**NHS Grampian
The Baird Family Hospital
Key Stage Assurance Review**

**Construction
KSAR Report**

Key Stage Assurance Review Report | Construction Stage

Diverse routing of A & B LV submain cables

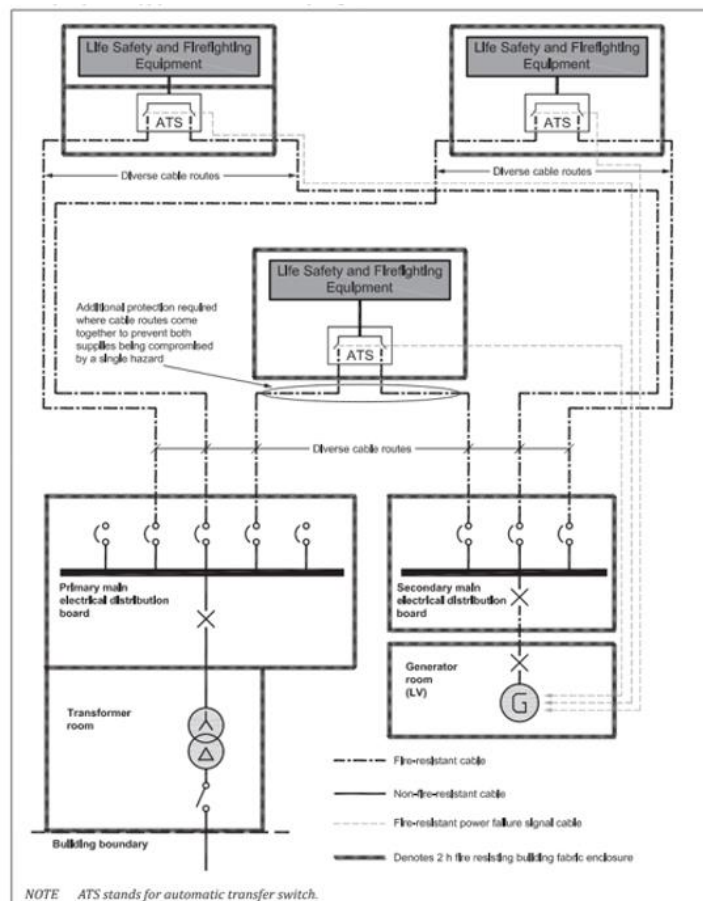
A&B LV switchrooms have been provided to incorporate A&B resilient supplies throughout the building. The A&B submain cable supplies exit the A&B switchrooms at lower ground floor level and enter into the same services distribution corridor. The main services distribution corridor which both sets of cables are routed through is a single fire compartment and as such is a single point of failure for both A&B supplies. If there was a fire within the main service corridor both sets of supplies could be lost effectively losing the whole supply to the hospital.

This is a departure and non-compliance with BS 8519 which states the following:
